MIL-C-38373B
AMENDMENT 2
21 October 1985
SUPERSEDING
AMENDMENT 1
20 Jan 1978

MILITARY SPECIFICATION

CAP, FLUID TANK FILLER

This amendment forms a part of Military Specification MIL-C-38373B, dated 1 Jul 1975, and is approved for use by all Departments and Agencies of the Department of Defense.

FIGURE 6. Lanyard attachment instruction tag.

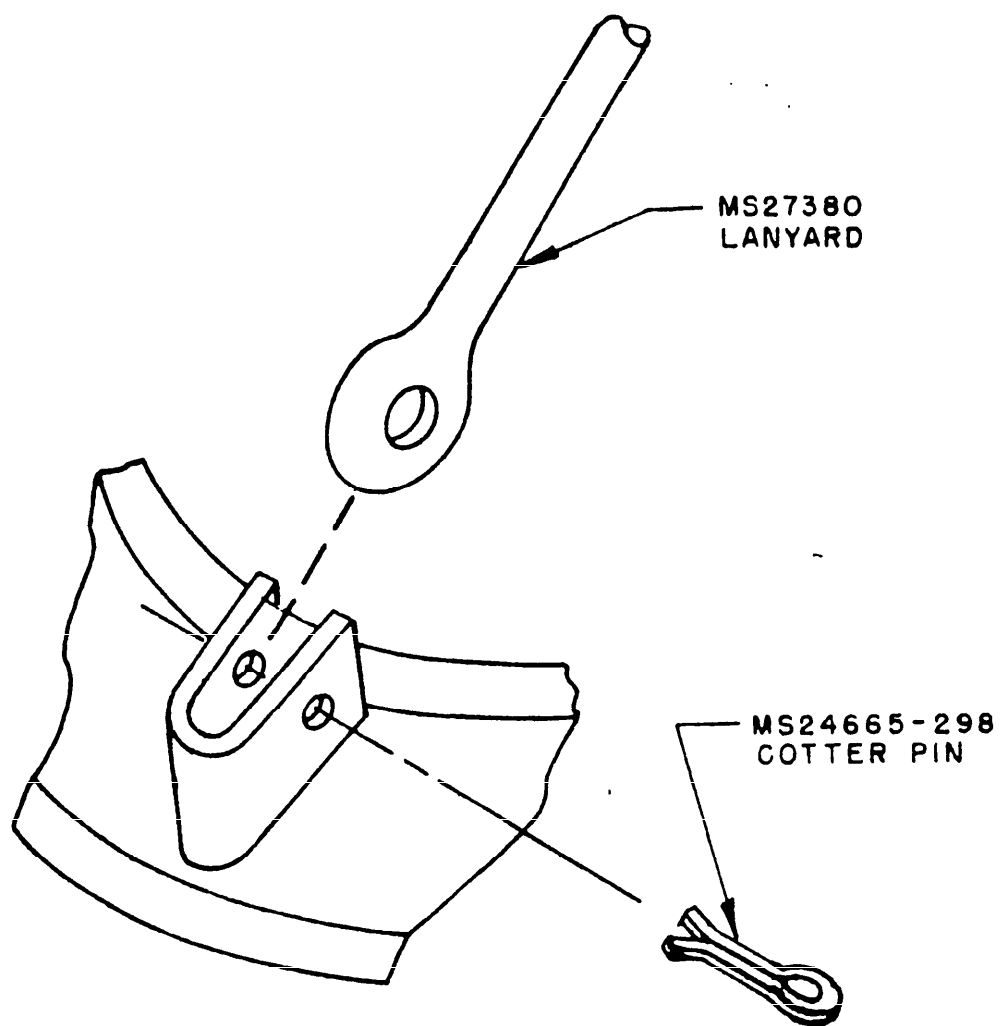
"NOTE: Attachment lanyards or chains are not included as part of cap assembly. One each MS24665-298 cotter pin will be furnished with all type III class A caps. During shipment the cotter pin will be attached to the cap along with a shipping tag in accordance with figure 6."

*Add Figure 6: Figure 6 forms page 5 of this amendment.

FIGURE 5. Lanyard-to-cap attachment.

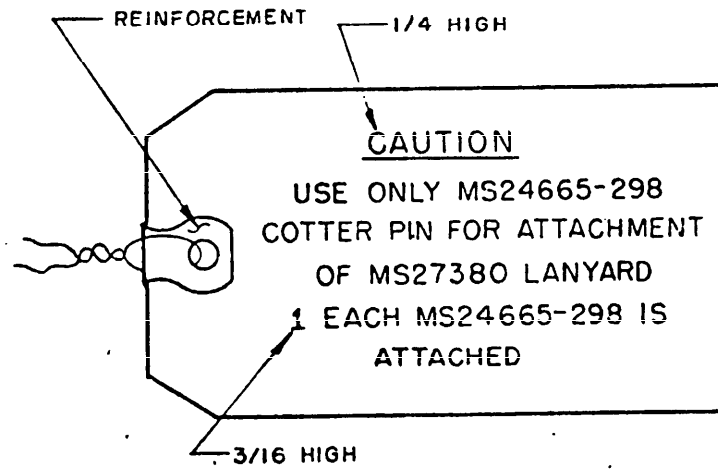
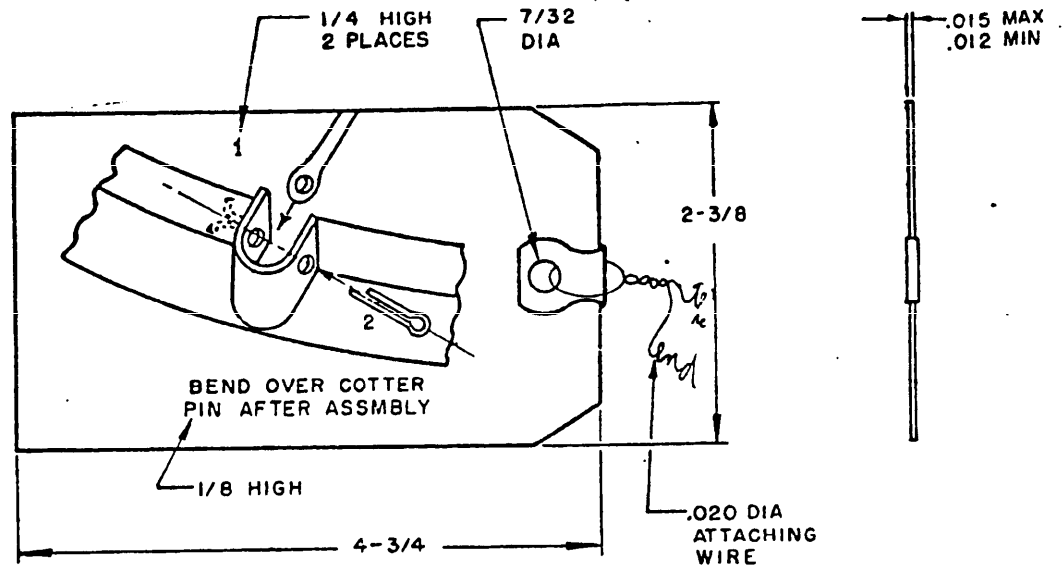
"3.5.6.1 Replacement of chain or lanyard. The time required to remove and replace the chain or lanyard shall not exceed 5 minutes using standard tools. It shall be possible to accomplish this replacement without disturbing the factory adjustment of the latching mechanism. For type III class A caps, the lanyard-to-cap attachment shall be by means of an MS24665-298 cotter pin as shown on figure 5."

Add FIGURE 5: Figure 5 forms page 4 of this amendment.

- a. Type III class A caps - Polyurethane lanyard in accordance with MS27380 with lanyard-to-cap attachment provisions as shown on figure 5.
- b. Type I and II caps - Weldless beaded chain in accordance with RR-C-271, type II, class 5, with chain-to-cap attachment provisions to meet the requirements specified herein.
